# Access Compliance Report

## Public Rights-of-Way

### (Curb Ramps)

Intersection ID: 32079	Main Street: ASHGROVE LN	Cross Street: KEEGAN_WY	Location:	N
ADA ID: 27656F93DA64	Ramp Type: Perp	Initial Pass/Fail: Fail	Overall Compliance: No	Severity Score: 13.75
Codes/Mitigation Info/Possible Solution		Field Measurements/Component Compliance

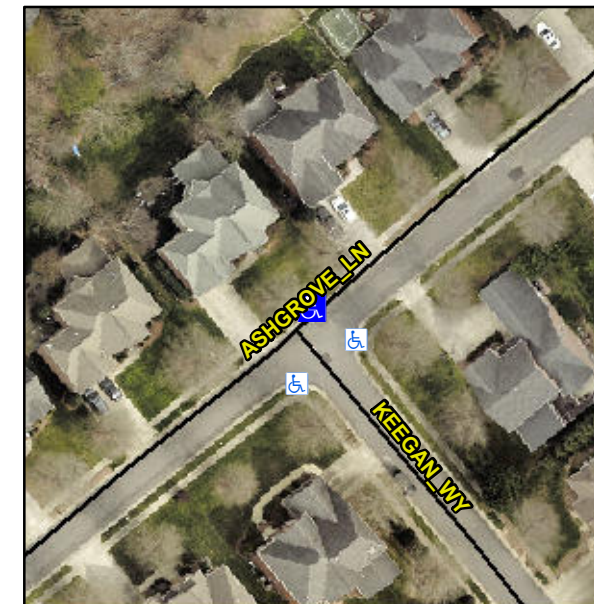
**Not Found, R304.2.2, R304.5.3**

Compliance	Description	Data	Compliance	Description	Data
N/A	Ramp Length (in)	49.0	No	Ramp Slope (%)	9.9
Yes	Ramp Width (in)	48.0	No	Ramp XSlope (%)	4.0
N/A	Flare Type LT	N/A	N/A	Flare Type RT	N/A
N/A	Flare Slope LT (%)	N/A	N/A	Flare Slope RT (%)	N/A
N/A	Flare Traversable LT?	N/A	N/A	Flare Traversable RT?	N/A
N/A	Landing Length (in)	N/A	N/A	DWS Provided?	N/A
N/A	Landing Width (in)	N/A	N/A	DWS Contrast?	N/A
N/A	Landing Slope (%)	N/A	N/A	DWS Length (in)	N/A
N/A	Landing X Slope (%)	N/A	N/A	DWS Full Width?	N/A
N/A	Landing Curb? (Y/N)	N/A	N/A	DWS Offset (in)	N/A
N/A	Shared Landing?	N/A			
N/A	Gutter Ponding?	N/A	N/A	Gutter Slope (%)	N/A
N/A	Gutter Lip Ht (in)	N/A	N/A	Gutter X Slope (%)	N/A
N/A	Painted X Walk1?	No	N/A	Painted X Walk2?	N/A
	X Walk 1 Direction	To SE		X Walk 2 Direction	N/A
N/A	X Walk 1 Width (in)	N/A	N/A	X Walk 2 Width (in)	N/A
	X Walk 1 Slope (%)	1.1		X Walk 2 Slope (%)	N/A
	X Walk 1 X Slope (%)	2.7		X Walk 2 X Slope (%)	N/A

**Remove & Replace Entire Ramp.**
